UNITED STATES PATENT AND TRADEMARK OFFICE

10/812,618

Office Action Summary	Application No.		Applicant(s)	
	10/812,618		DHUPER ET AL.	
	Examiner		Art Unit	
	Teena Mitchell		3771

DETAILED ACTION

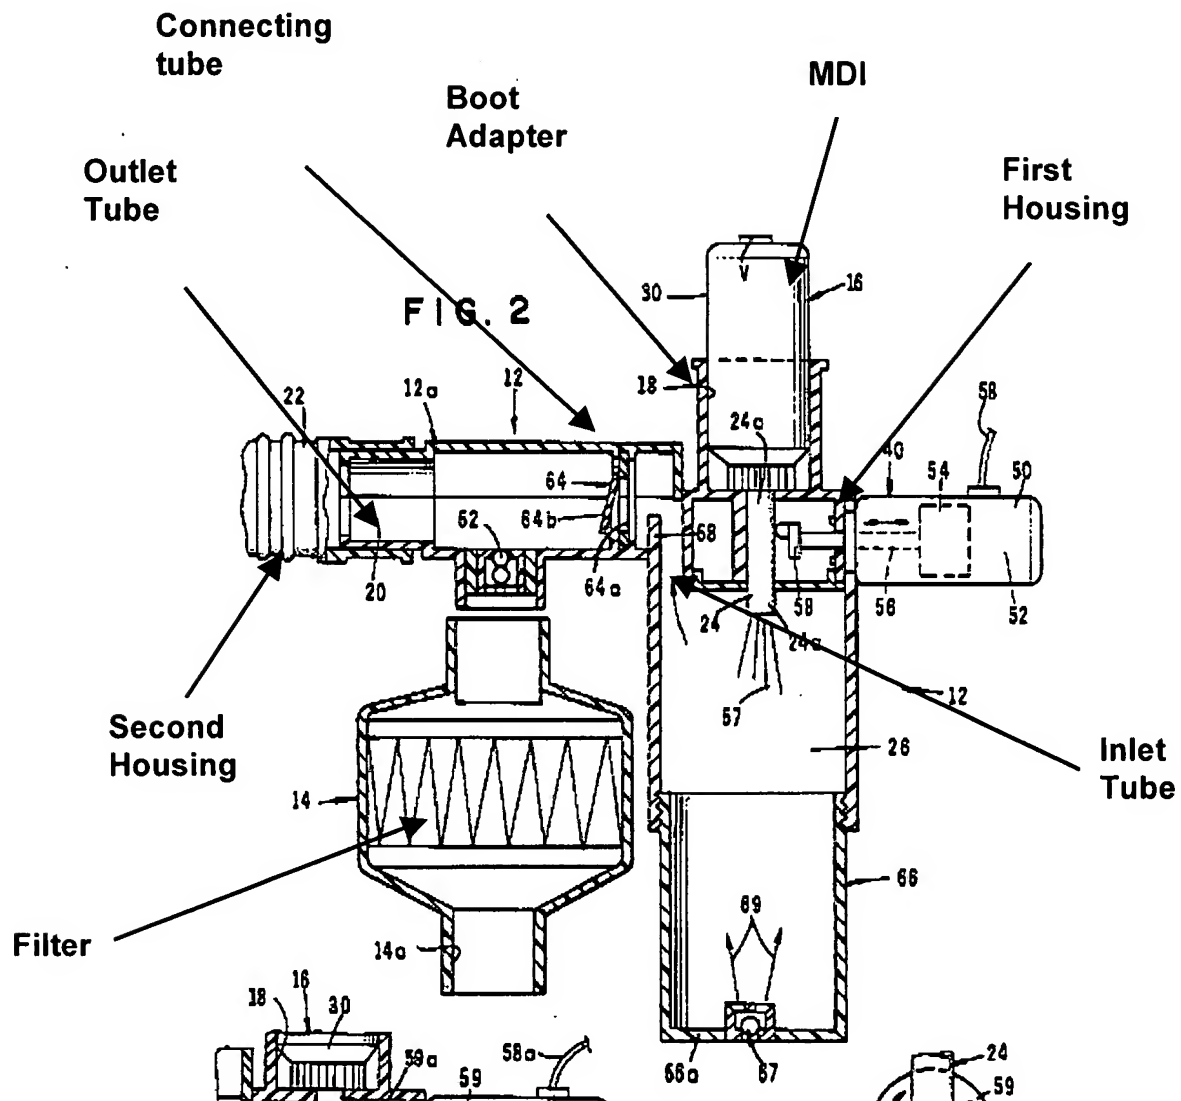
Regarding claim 1, King discloses a fixed first housing with a configuration of a cylinder (note illustration of Fig. 2 below), a fixed second housing; the first housing that is connected to the second housing through one of more peripheral and/or central hollow connecting tubes (note illustration of Fig. 2 below); the first housing with an inhalation/exhalation outlet tube at an inhalation/exhalation end of the first housing (Fig. 2 below); the inhalation/exhalation outlet tube with an inhalation/exhalation outlet port at the end of the inhalation/exhalation outlet tube (Fig. 2 below); the first housing with an inlet tube at a diametrically opposite end of the inhalation/exhalation outlet tube (Figs. 2 below); the inlet tube with an inlet port at an end of the inlet tube (Fig. 2 below); a boot adapter panel (Figs. 2 below) with an opening for receiving a boot of an MDI inhaler; a one-way inhalation flap valve assembly (at 64) that comprises an inhalation flap valve (at 64b), and a valve seat (64a) for the inhalation flap valve that is disposed in the outlet port of the outlet tubing of the first housing; the one way valve assembly (at 64) whereby inhalation by a patient through the inhalation/exhalation outlet port will cause the inhalation flap valve to move away from the inhalation flap valve

seat (64a) to allow one way flow of gas(es) from the first housing to a mouth piece or a face mask (Col. 3, lines 52-59) through the inhalation/exhalation outlet port of the first housing presses the inhalation flap against the inhalation flap valve seat (64a) to prevent the flow of exhaled gas into the first housing; a one way exhalation flap valve assembly (at 62), the difference between King and claim 1 is the exhalation flap valve seat. King discloses a ball check valve in the exhalation flap assembly, which does have a valve seat however not the same seat as the flap valve of the inhalation valve, inasmuch as the inhalation type flap valve as well known it would have been obvious to one of ordinary skill in the art to substitute the ball check valve in the exhalation pathway to the valve assembly of the inhalation pathway as one well known valve means for another. King discloses an exhalation filter (14).
